ATTACHMENT 2

TECHNICAL SPECIFICATIONS/BASES CHANGES

9502130113 950130
PDR ADDCK 05000269
P PDR

Table 3.8-1

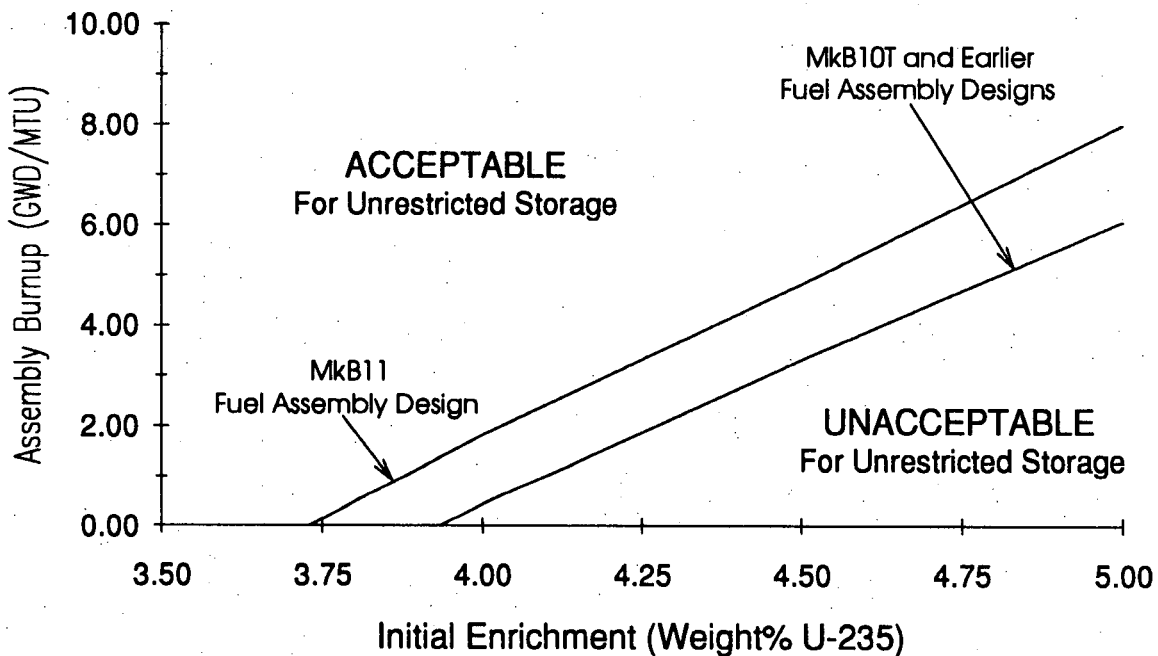
Fuel which does not meet the requirements of Table 3.8-1 may be qualified for Unrestricted storage by means of an analysis using NRC approved methodology to assure that k_{eff} is less than or equal to 0.95.

Likewise, previously unanalyzed fuel up to 5.0 weight% U-235 may be qualified for Restricted storage by means of an analysis using NRC approved methodology to assure that k_{eff} is less than or equal to 0.95.

Table 3.8-2

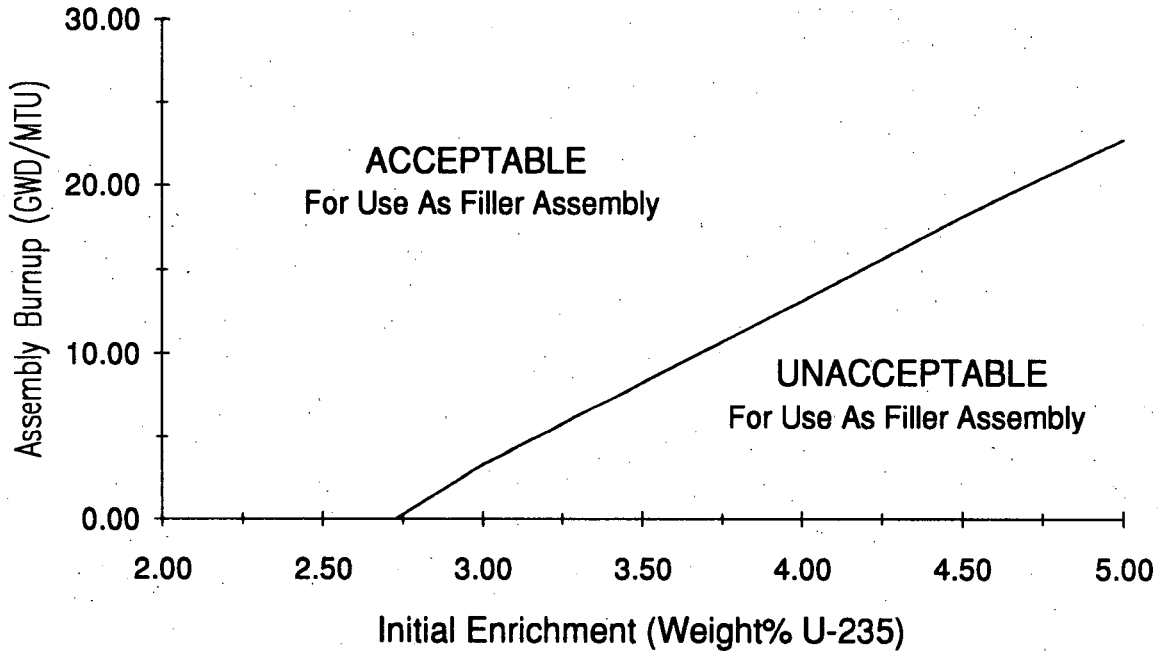
Fuel which does not meet the requirements of Table 3.8-2 may be qualified for use as a Filler Assembly by means of an analysis using NRC approved methodology to assure that k_{eff} is less than or equal to 0.95.

Table 3.8-3

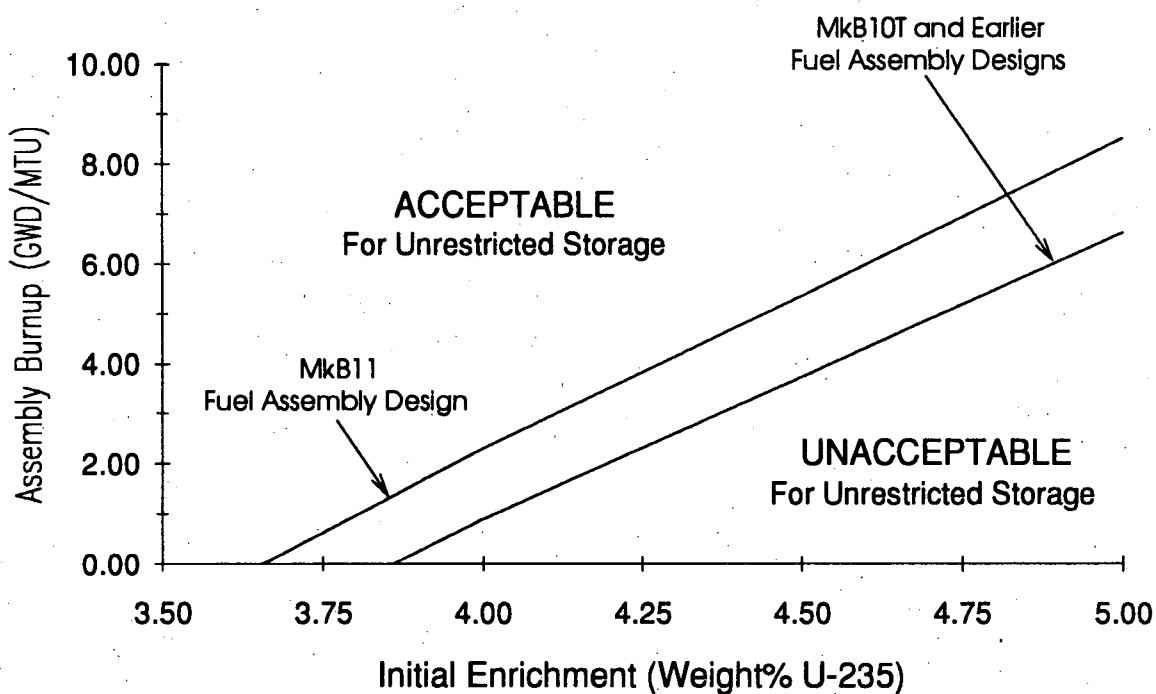
Fuel which does not meet the requirements of Table 3.8-3 may be qualified for Unrestricted storage by means of an analysis using NRC approved methodology to assure that k_{eff} is less than or equal to 0.95.

Likewise, previously unanalyzed fuel up to 5.0 weight% U-235 may be qualified for Restricted storage by means of an analysis using NRC approved methodology to assure that k_{eff} is less than or equal to 0.95.

Table 3.8-4

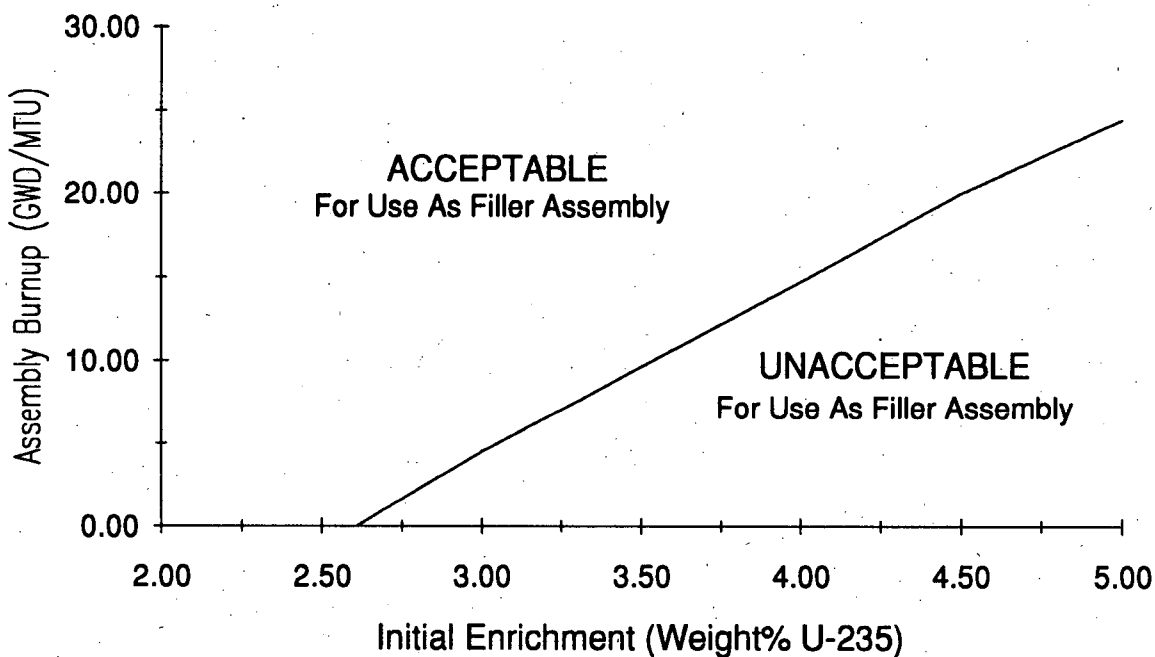
Fuel which does not meet the requirements of Table 3.8-4 may be qualified for use as a Filler Assembly by means of an analysis using NRC approved methodology to assure that k_{eff} is less than or equal to 0.95.
